Staff Report

Subject Property: Lewis Rd and Larkfield Way (Wildwood Place)

Applicant requests a change in zoning conditions. Please see zoning condition (Figure 4).

Staff Analysis: (Updated as of 06/10/2026)

Figure 4 – Final Plat (b)

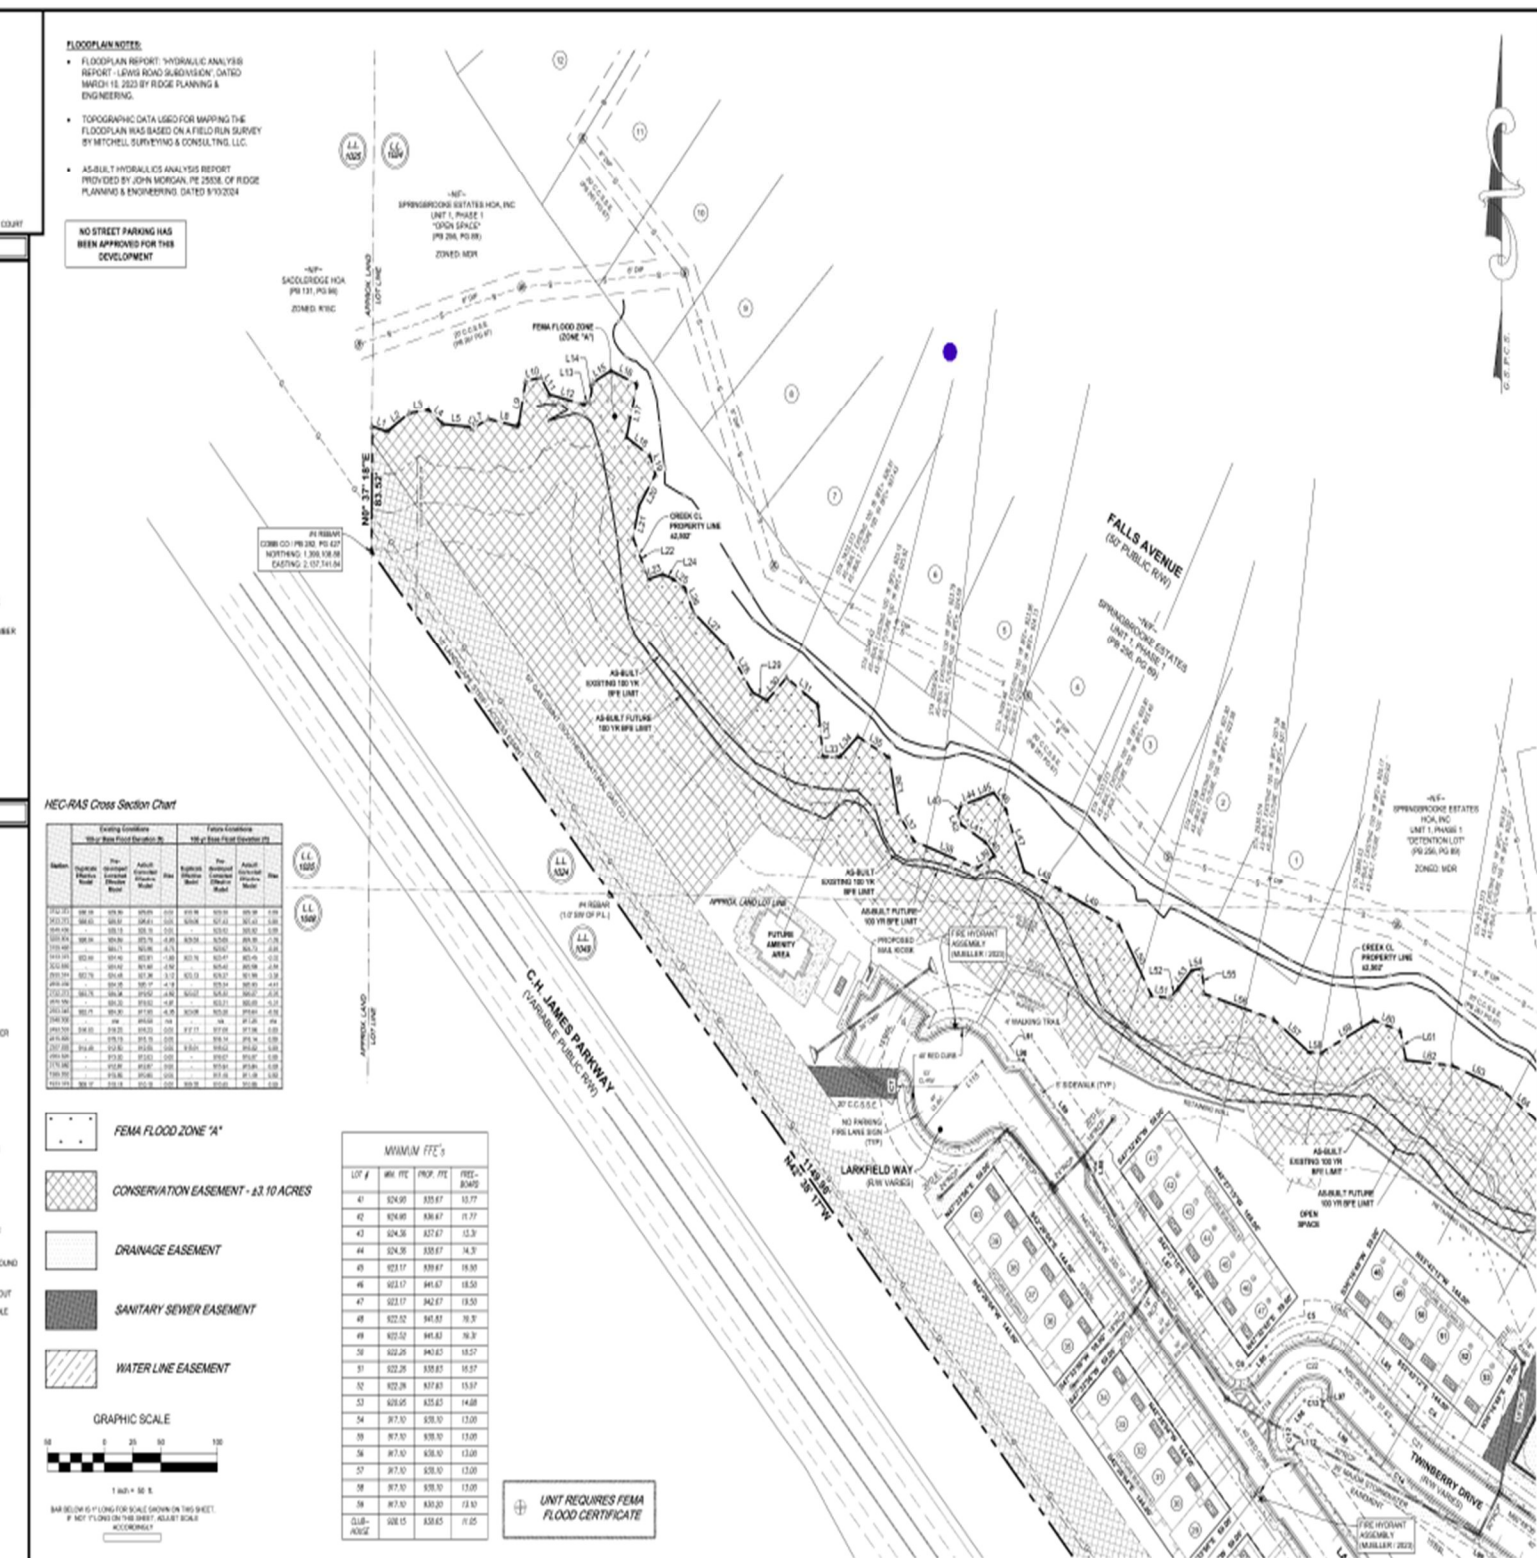
With documentation that has been received by Staff on 05/26/2026, the Applicant is withdrawing the request to remove the condition that homes must contain at least 50% brick on the rear and sides. This was originally for the 31 units that are highlighted in green stripes and have not been built yet on the Construction Plan (Figure 3).

Figure 6 – Construction Plans

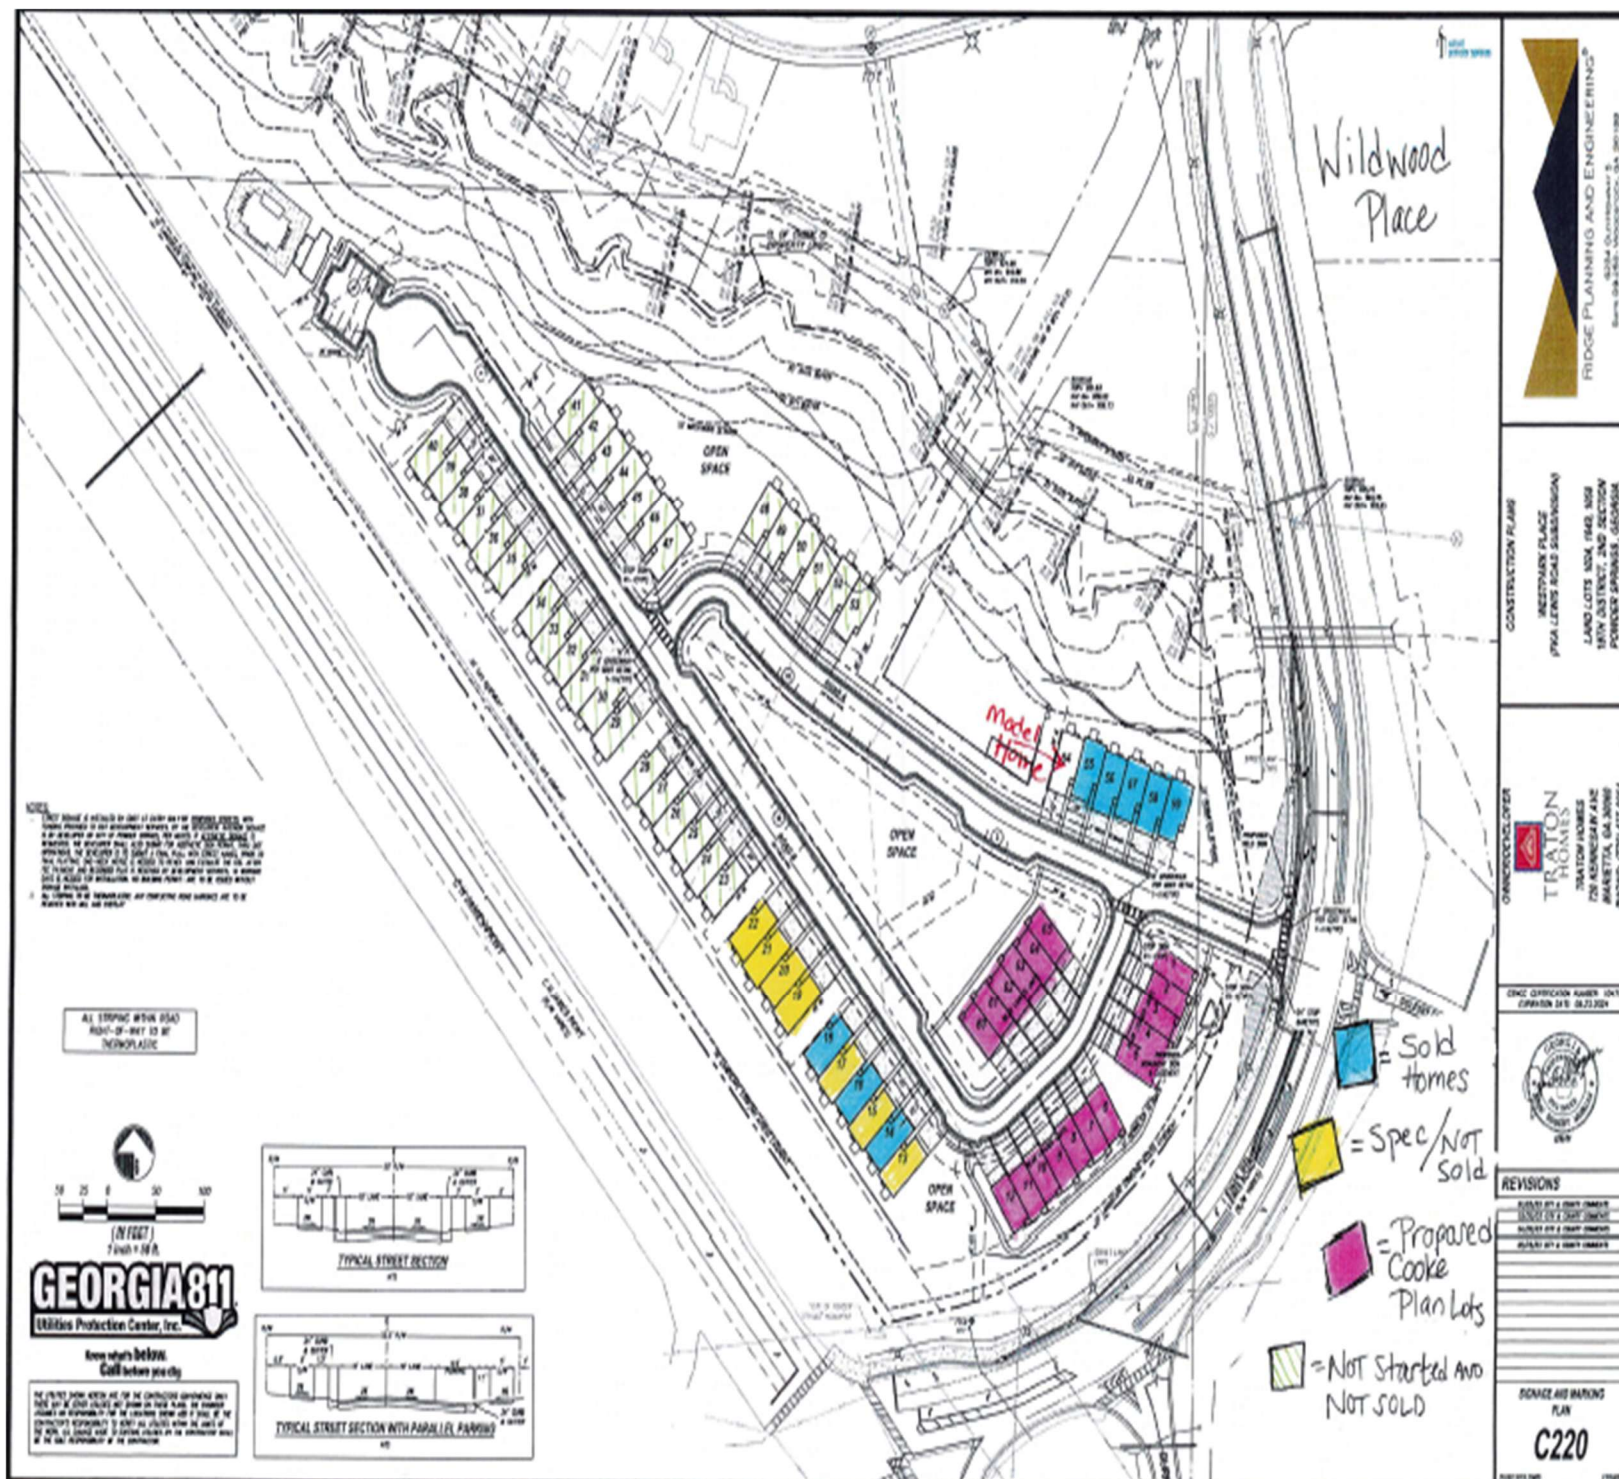
What Applicant is Proposing: To seek amendments to certain stipulations approved in the original application for rezoning being PZ22-003. Instead of 3 level townhomes with a rear entry 2-car garage, they request 2 level townhomes with a rear entry 1 car garage for all of the homes **highlighted in pink** on the Construction Plan (Figure 3). **This is for 18 units.** Also, for **31 units to remove the condition that the rear and sides of the two level townhomes must be min 50% brick or 50% stone for the remaining homes in the subdivision itself which are highlighted in green stripes** and have not been built yet on the Construction Plan (Figure 6). There are **65 units in total** in this subdivision.

What Applicant is Proposing: To seek amendments to certain stipulations approved in the original application for rezoning being PZ22-003. Instead of 3 level townhomes with a rear entry 2-car garage, they request 2 level townhomes with a rear entry 1 car garage for all of the homes highlighted in pink on the Construction Plan (Figure 3). This is for 18 units. Also, for 31 units to remove the condition that the rear and sides of the two-level townhomes must be min 50% brick or 50% stone for the remaining homes in the subdivision itself which are highlighted in green stripes and have not been built yet on the Construction Plan (Figure 6). There are 65 units in total in this subdivision.

As shown in the updated elevations received on May 26, 2026 (Figures 13(a) and 13(b)), the applicant requests a modification for the townhome units highlighted in pink on the Construction Plan (Figure 6). Rather than building the originally proposed three-story townhomes with rear-entry, two-car garages, the applicant proposes two-story

townhomes. These units would feature a rear-entry, one-car garage with dedicated driveway space to park two additional vehicles.

Recommendation: Staff recommends denying the request for a Change In Zoning Conditions to allow the applicant to modify the design of 18 of the townhomes from two-car garage units to one-car garage units. No market analysis has been provided to support the contention that one-car garage units would meet market need. Furthermore, the reduction in resident parking for these units may lead to on-street parking.

1. Request to modify build townhome units 1 - 12 AND 60 - 65 (per Final Plat dated 10/14/2024) as two-story townhomes with a rear entry, one-car garage with a two-car driveway. Applicant acknowledges that all other townhome units shall be two story or three-story with rear or front entry two-car garage, with two-car driveway to park two additional vehicles. Driveway shall be greater than or equal to 22-feet in length.

Figure 13(b) - Updated elevations (05/26/2026)

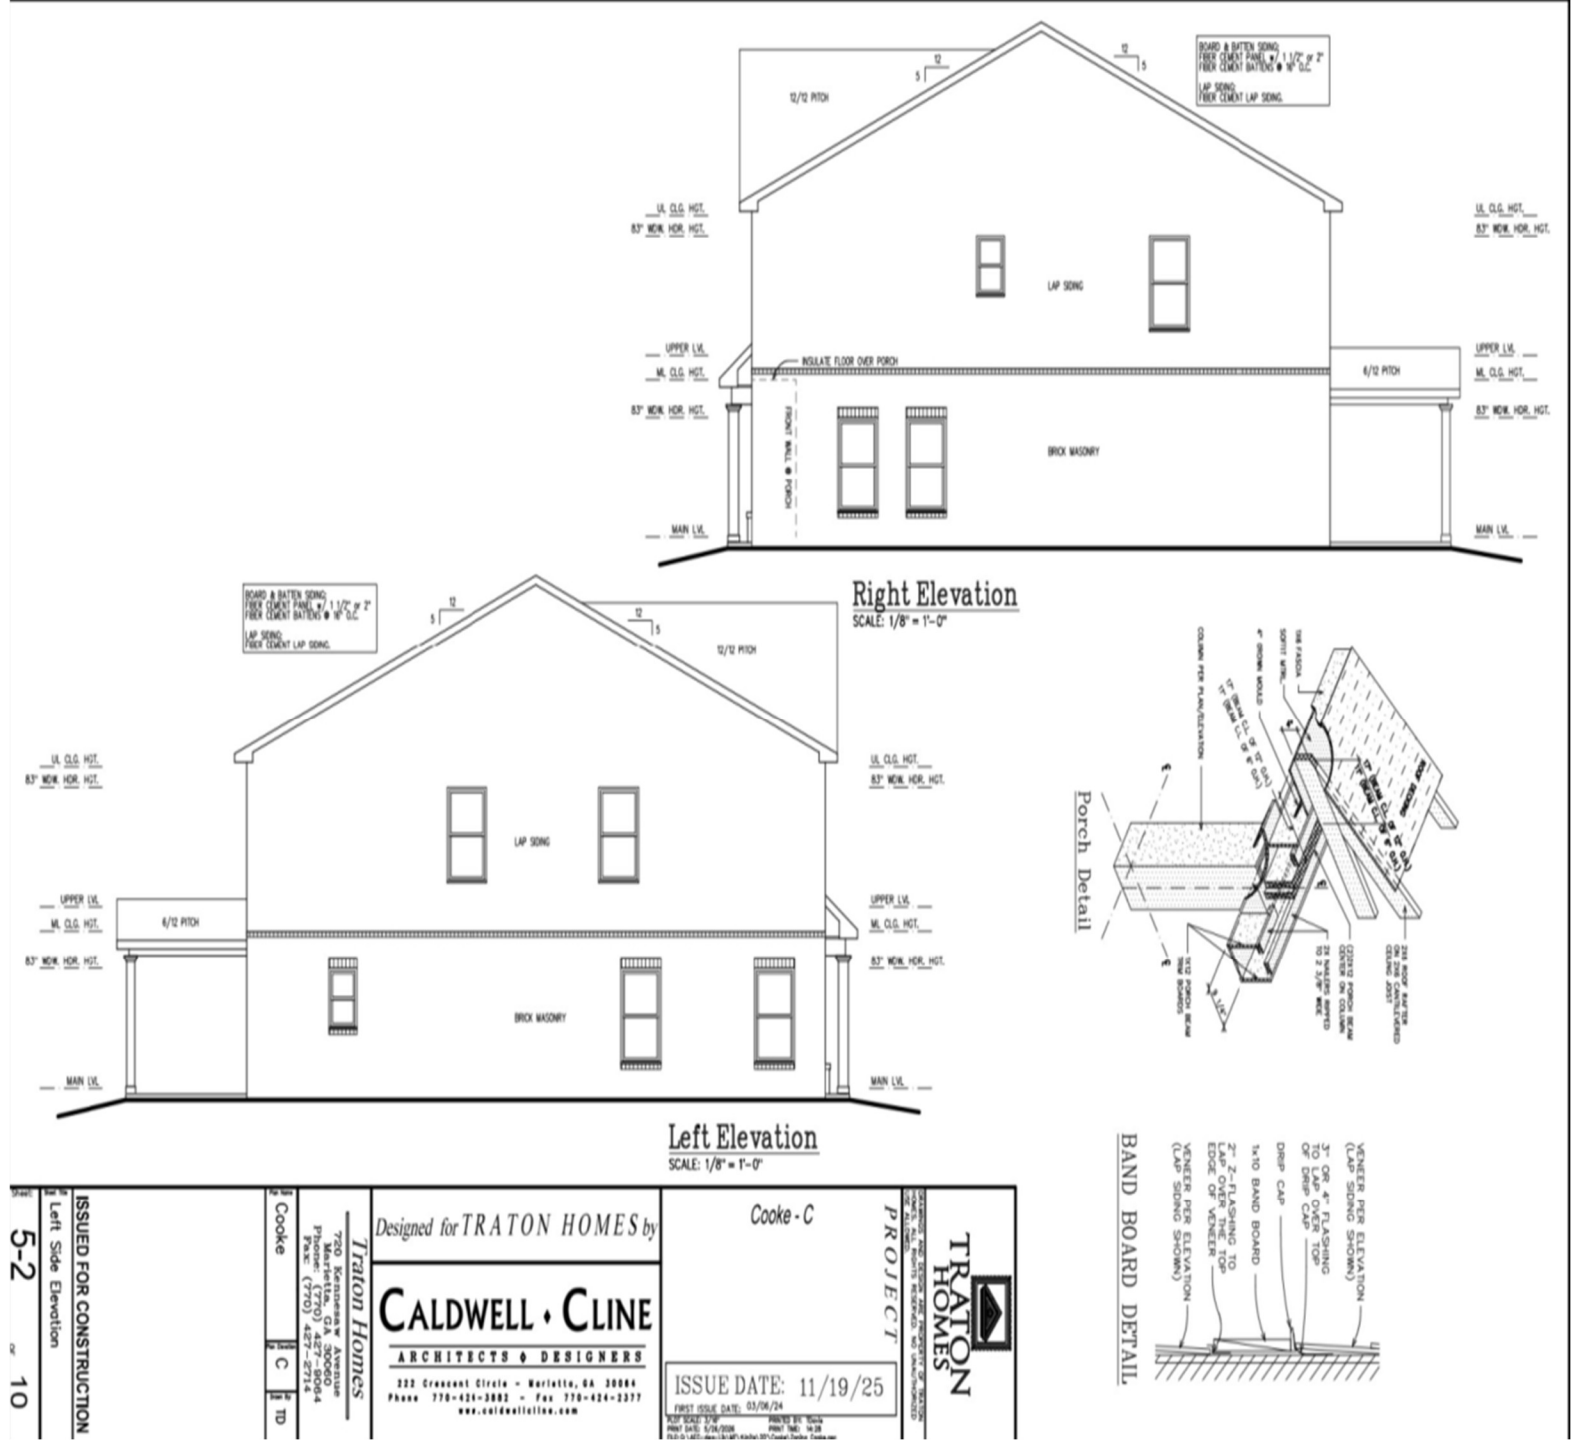
After evaluation of the pending request for change in zoning conditions, Traton has authorized the withdrawal of the request to remove the condition that homes must contain at least 50% brick on the rear and sides. Traton does however wish to pursue approval of the change in condition to allow for the single car, rear entry garage homes, which will contain a minimum of 50% brick on the rear and sides. An updated elevation of these homes is attached for reference and inclusion. This will allow for a change to a more affordable home but limited in number.

2. Applicant acknowledges the architectural style and composition of all units will be subject to a design review, and shall consist of traditional architecture on all sides, consistent with the architectural elevations submitted on May 2026. Consistent with the other homes in the neighborhood, variation will be provided using stone and different shades of brick, and by mixing front facades of 50% brick and 100% brick. All side elevation will contain brick or stone no less than 50%, and fenestration shall be required on all end units. All rear elevations will contain brick and stone not less than 50% where exposed to the right-of-way.
